UNITED STATES PATENT AND TRADEMARK OFFICE

APPLICATION NO.	FILING DATE	FIRST NAMED INVENTOR	ATTORNEY DOCKET NO.	CONFIRMATION NO.
10/510,838	05/18/2005	Emil Edwin	0001885USU/3053	3864

Office Action Summary

DETAILED ACTION

Fig. 1

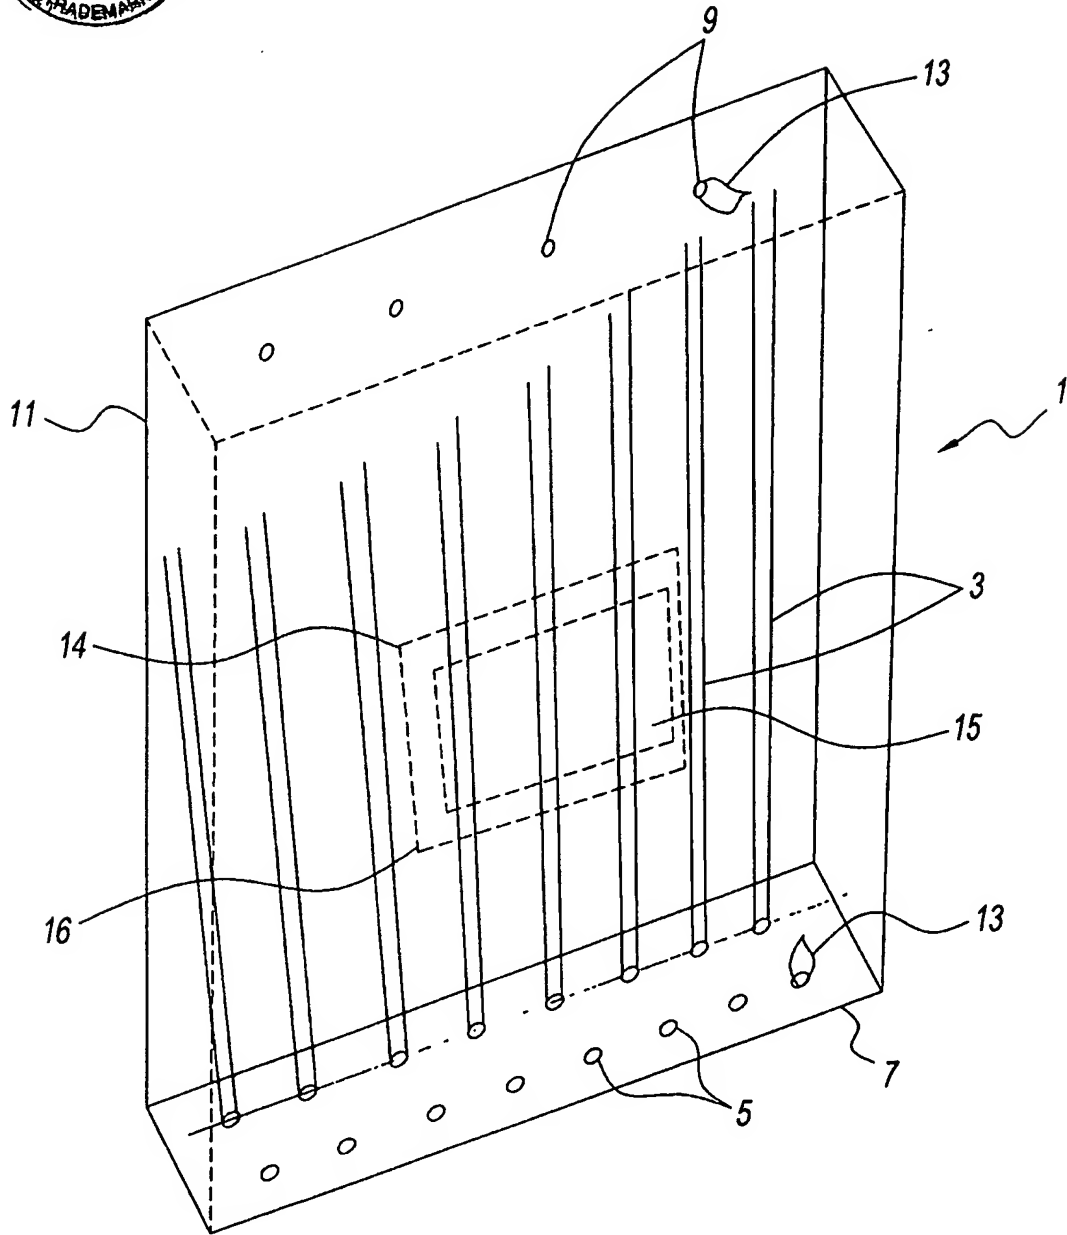
The Replacement drawing Figure 1 and new Figure 3 have not been approved as they fail to comply with 37 CFR 1.84(p)(5) because they include the following reference character(s) not mentioned in the description: Reference characters 14 and 16 (Figure 1). Reference character 20 (Figure 3).

NOT
Approved
of
Reference 10/24/06
NUMERALS 14, 16
missing in
spec.

Fig. 2

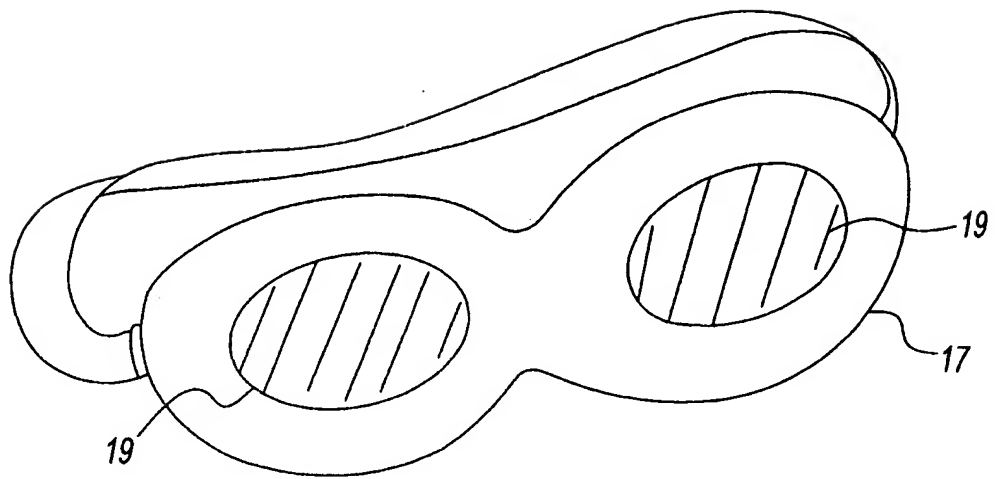
The Replacement drawing Figure 2 has been approved.

Fig. 3

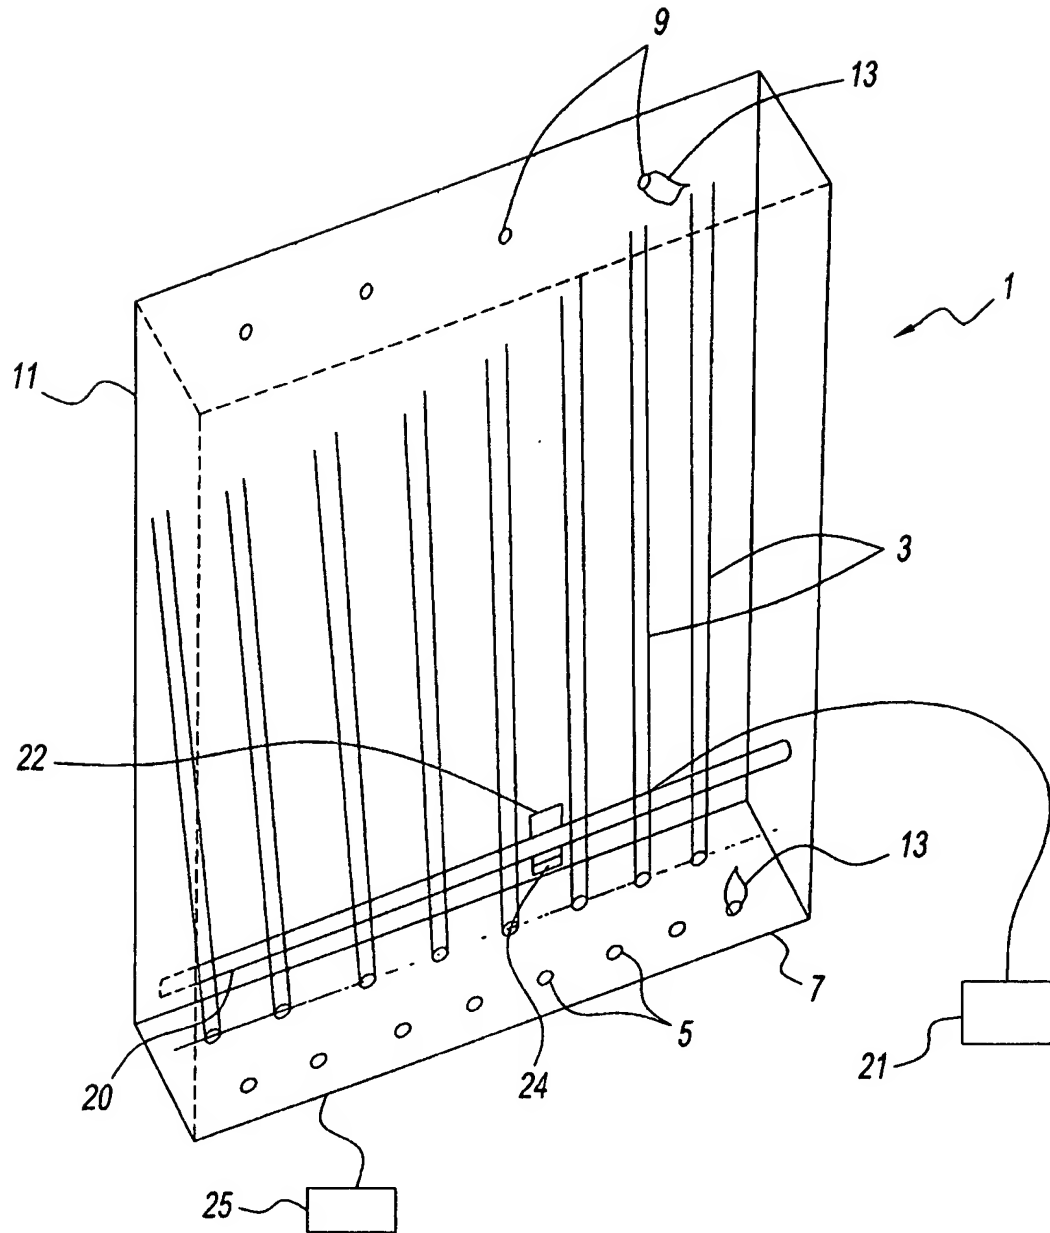
Newly added drawing Figure 3 has not been approved as it introduces new matter. See below.

The particular arrangement of elements illustrated in Figure 3 including, and not limited to, the use of a bar oriented at the particular orientation and location shown, the manner in which the relay connects to the bar, and the particular location of the filter (24).

NOT APPROVED
10/24/02
NEW MATTER
